Truck			Bus			Power Solutions			
4	PGRT	LPGRS	4	FKN	CK	P93	P96	E2011	PS2024
-	-	-	-	-	X	-	-	-	-

Electric power supply for accessories to P503 suddenly disappears

348 909

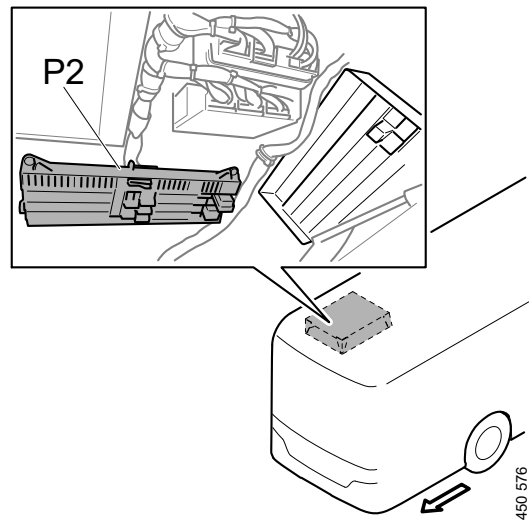
The electric power supply to the body can suddenly shut down. The cause is a manufacturing defect of a cable harness.

2. Locate central electric unit P2 and control unit E111 (BCI2/BCI3) and relay R115.
(usual placement according to illustration)

3. Connect the diode according to the diagram below.

Start by measuring to confirm that the diode is incorrectly oriented, use a multimeter.

If so, locate the diode between *E111/B:2* and *R115:2*.

Then cut the electrical cable a bit away from the diode on both sides, rotate it and reattach with suitable jointing sleeves.

Measure again to confirm that the diode is now correctly attached.
